Access Compliance Report

Public Rights-of-Way

(Curb Ramps)

Intersection ID: 48763	Main Street: SONOMA_VALLEY_DR	Cross Street: N/A	Location:	N
ADA ID: 72C6E885C4C7	Ramp Type: Perp	Initial Pass/Fail: Fail	Overall Compliance: No	Severity Score: 12.5
Codes/Mitigation Info/Possible Solution		Field Measurements/Component Compliance

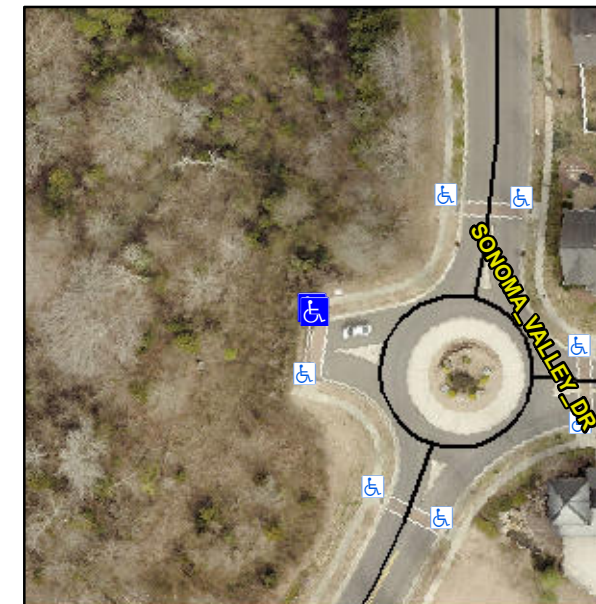
Remove & Replace Entire Ramp.

R304.5.3
